ADDENDUM NO. 3

City of Tukwila, Washington S Boeing Access Road over Airport Way Bridge Seismic Retrofit Project

City Project No.: 91310407

DATE OF ADDENDUM ISSUE: March 31, 2020

C9

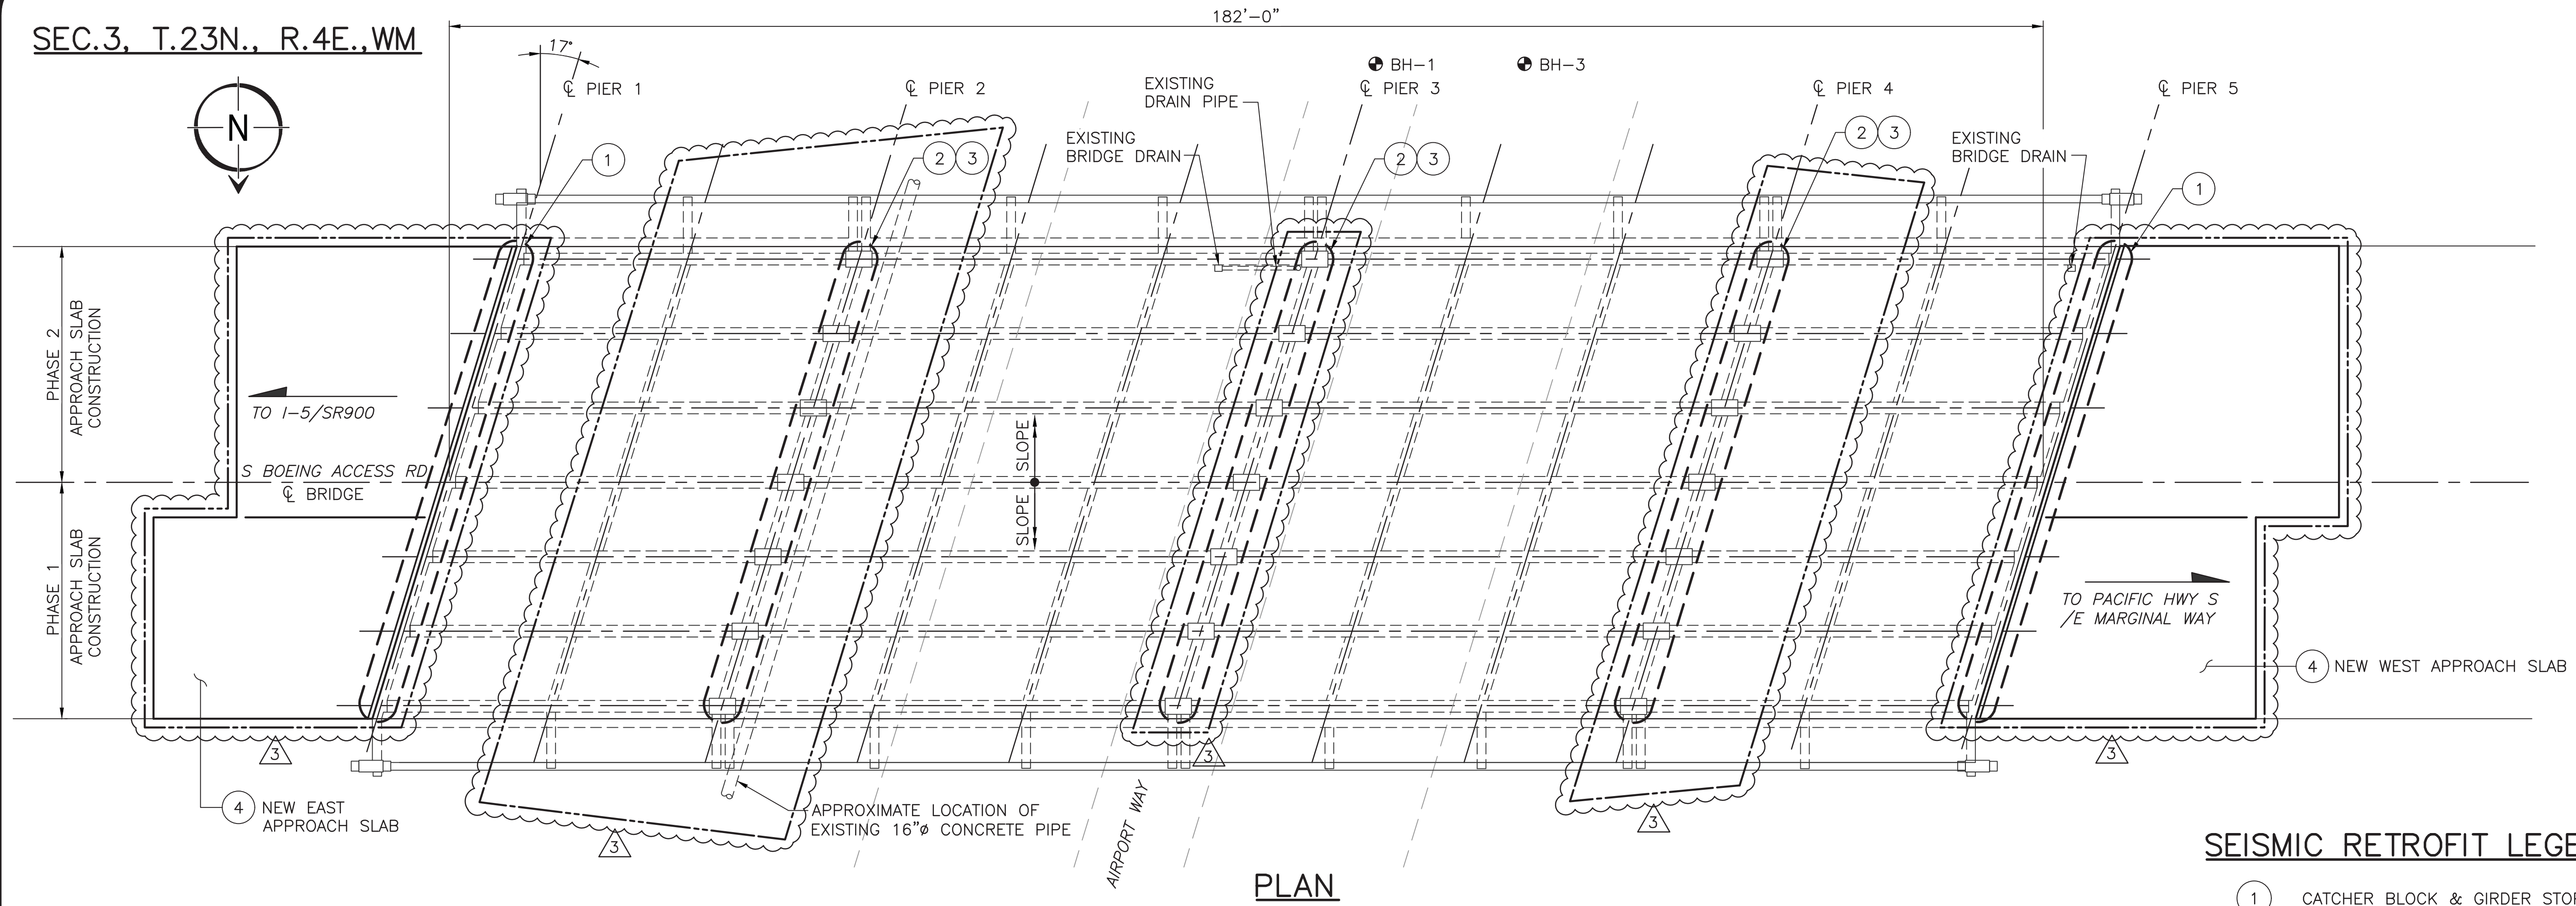
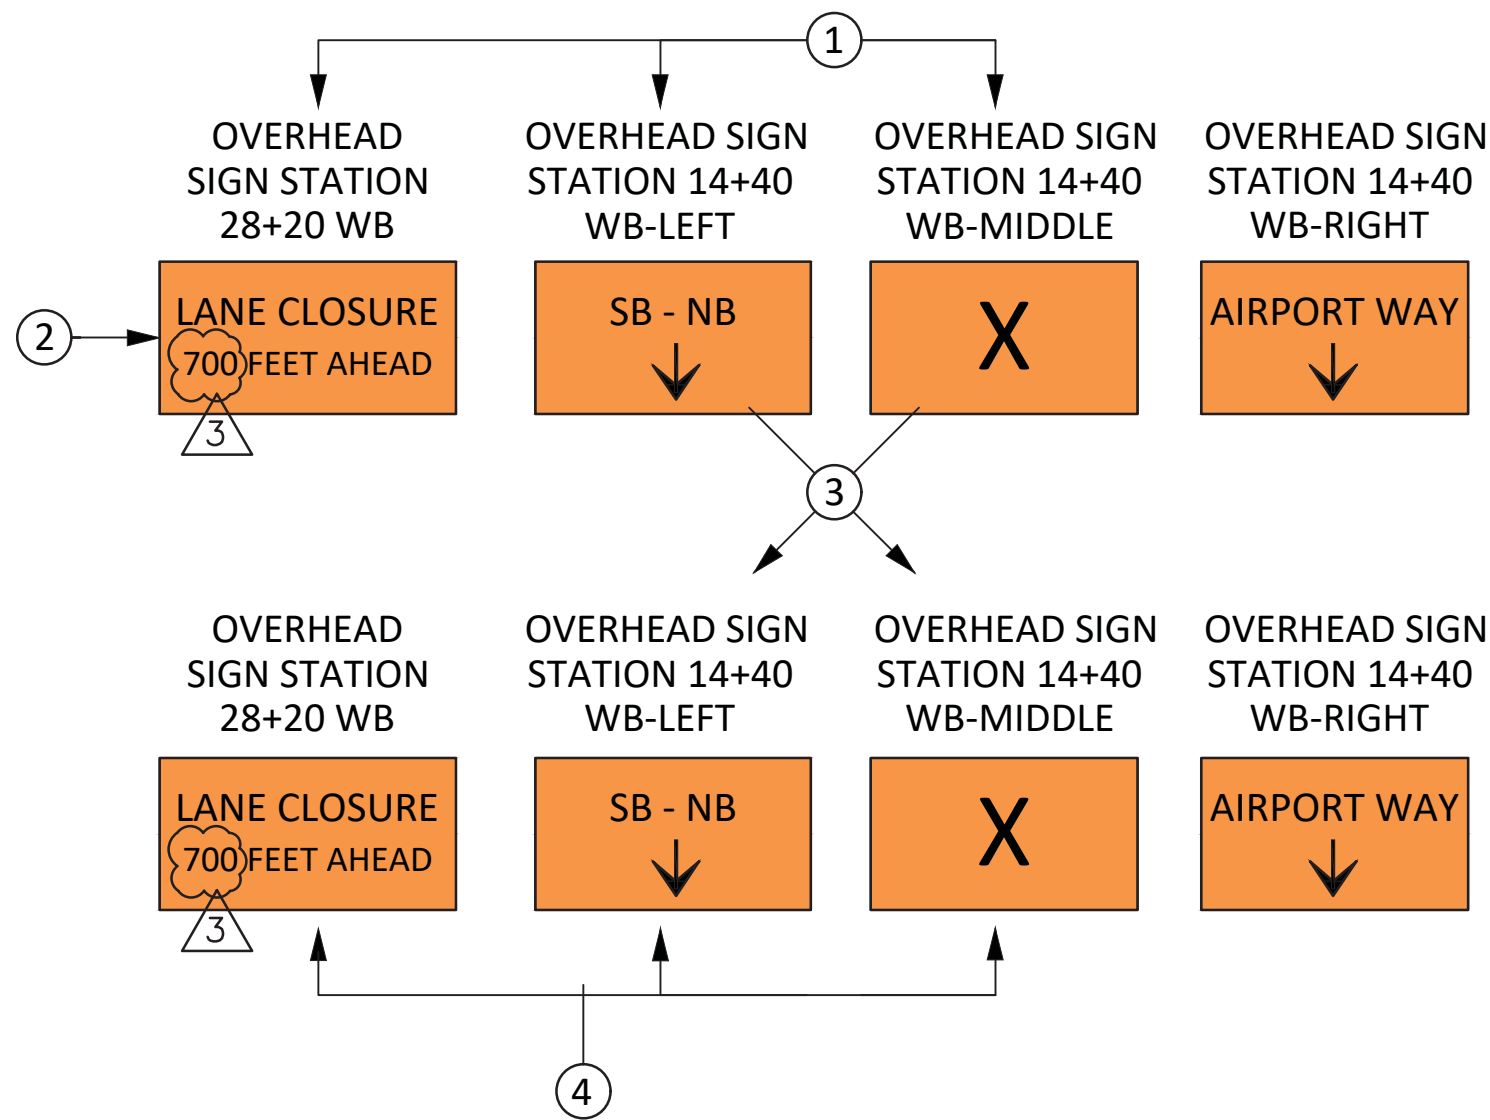
7. Plan Sheet 12 of 23:

DELETE Sheet 12 of 23 and REPLACE with the attached Sheet 12 of 23.

The following changes have been made:

- Revised Overhead Sign Patches Detail to correct lane closure distance.

S1

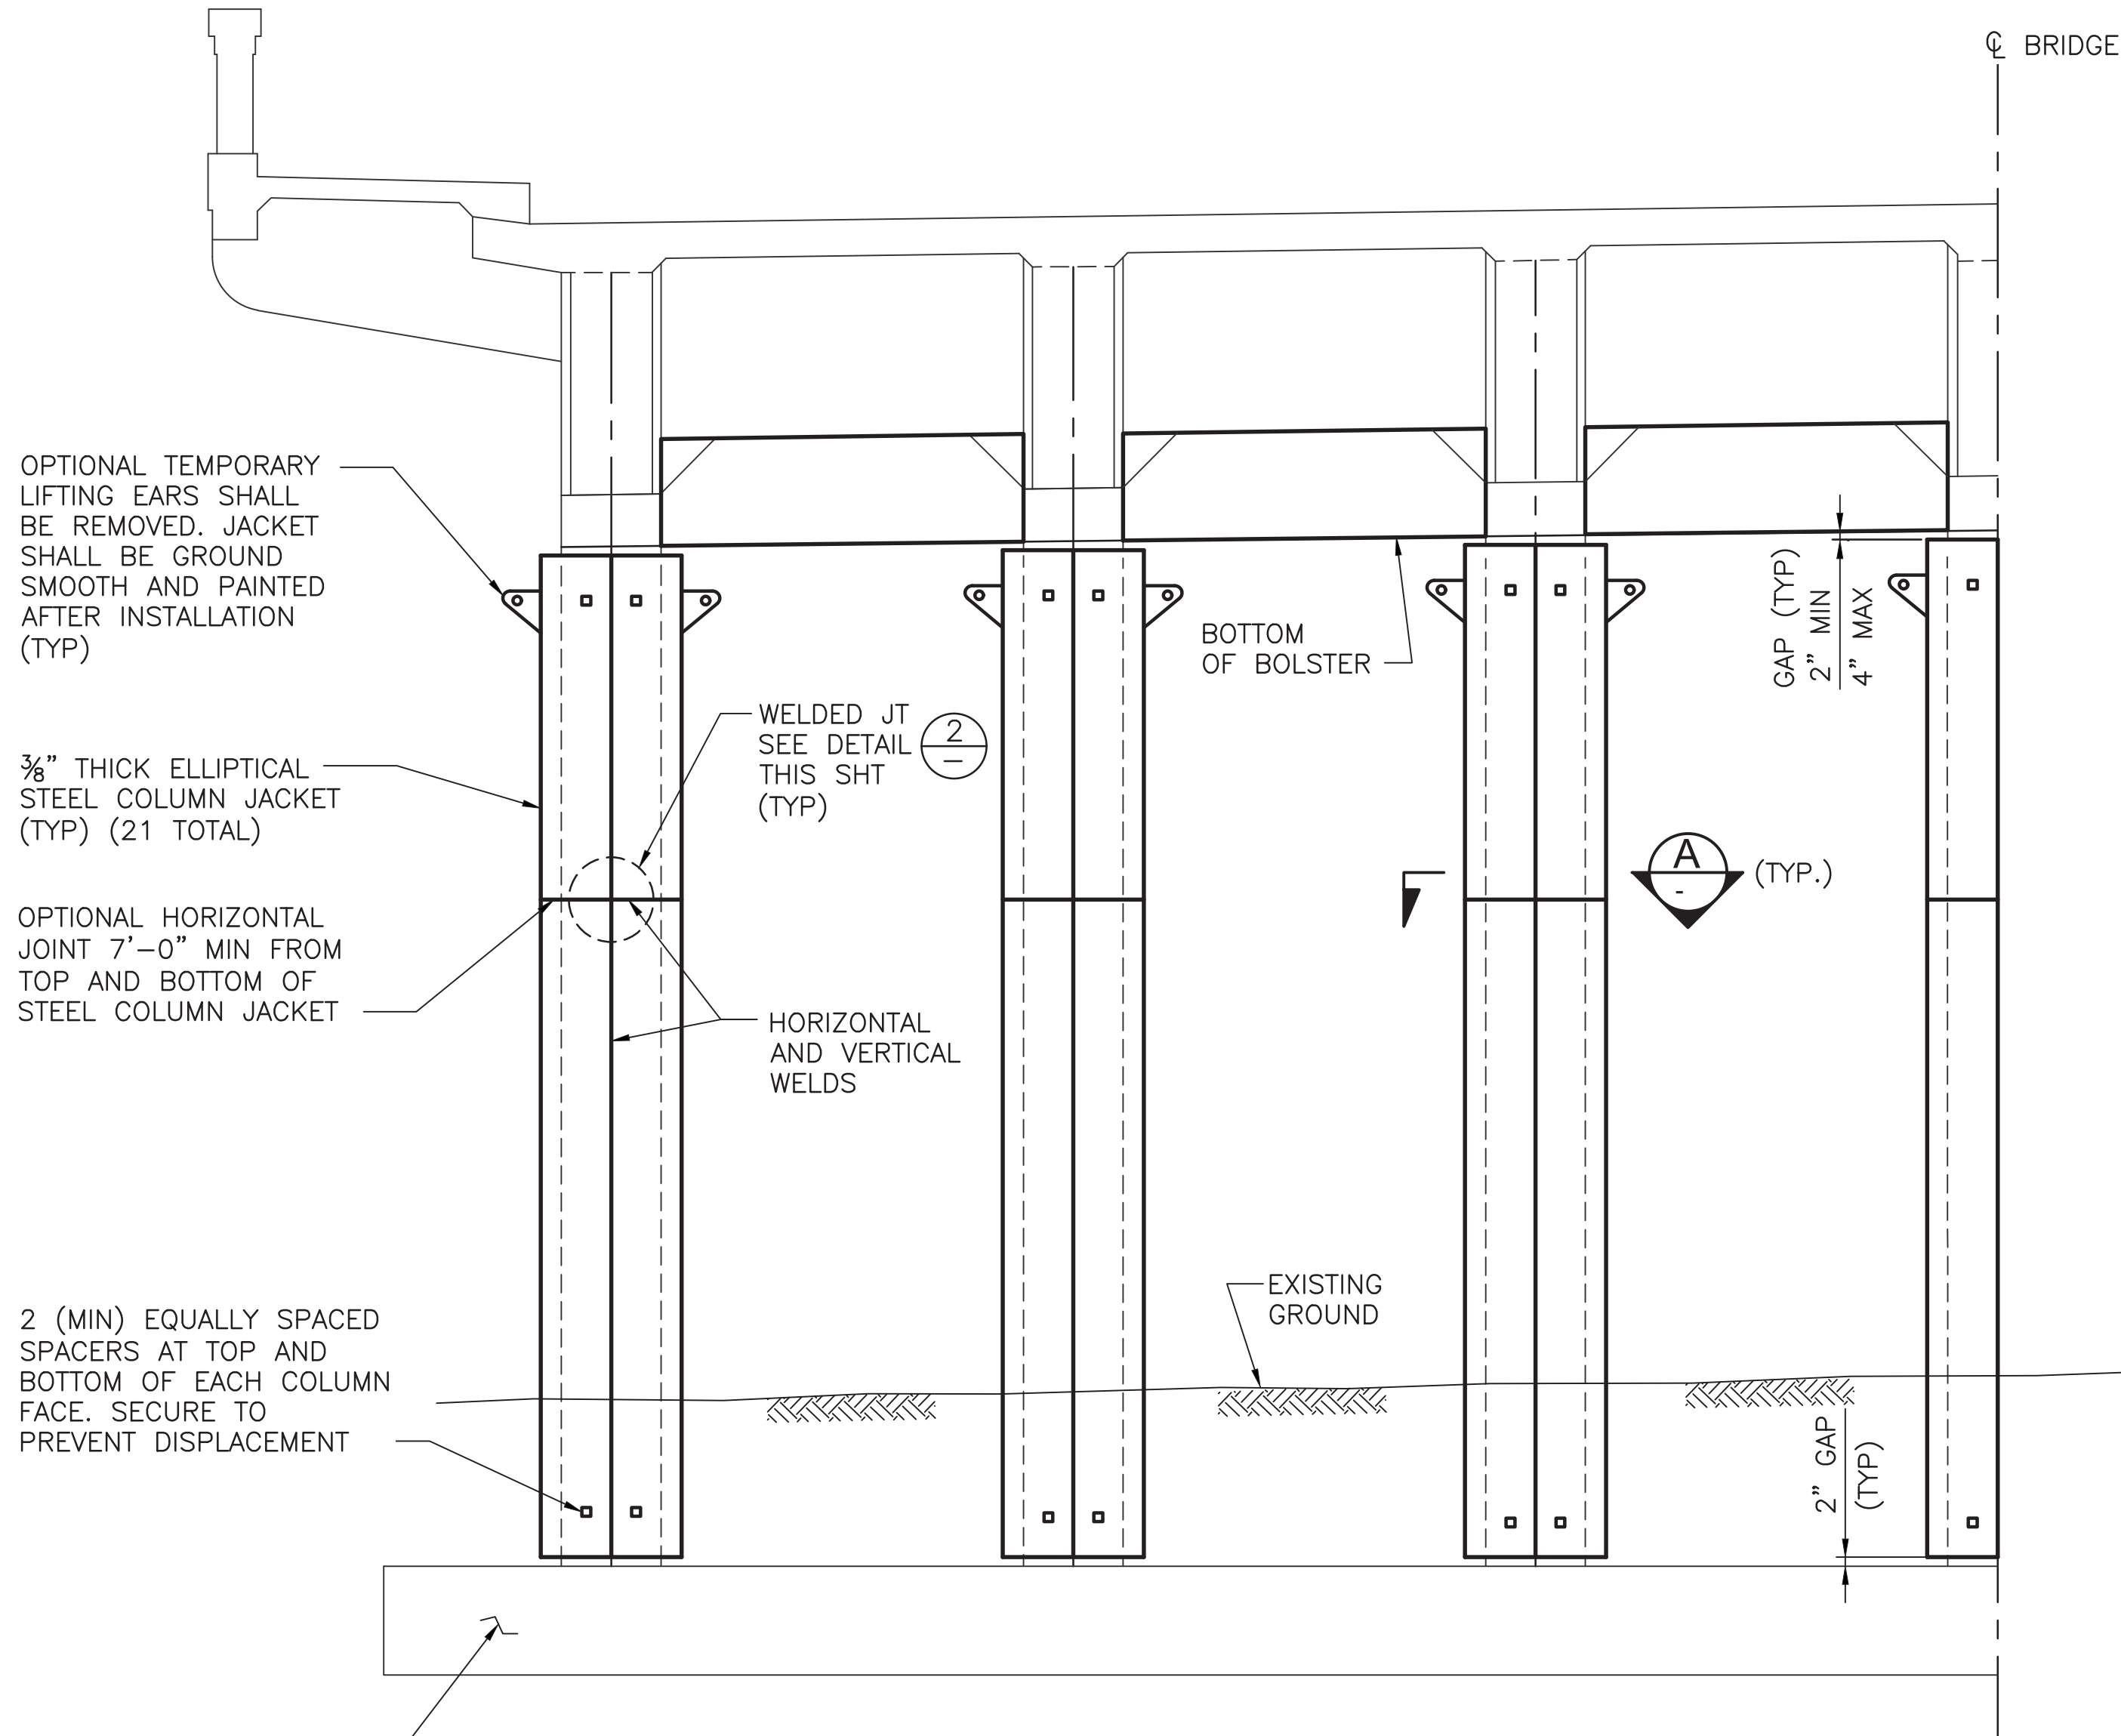
8. Plan Sheet 13 of 23:

DELETE Sheet 13 of 23 and REPLACE with the attached Sheet 13 of 23.

The following changes have been made:

- Proposed limits of shoring and excavation added.

- 1 CATCHER BLOCK & GIRDER STOP
- 2 NEW CONCRETE BOLSTERS
- 3 NEW STEEL COLUMN JACKETS
- 4 NEW APPROACH SLAB
- PROPOSED WORK AREA
- PROPOSED LIMITS OF SHORING AND EXCAVATION
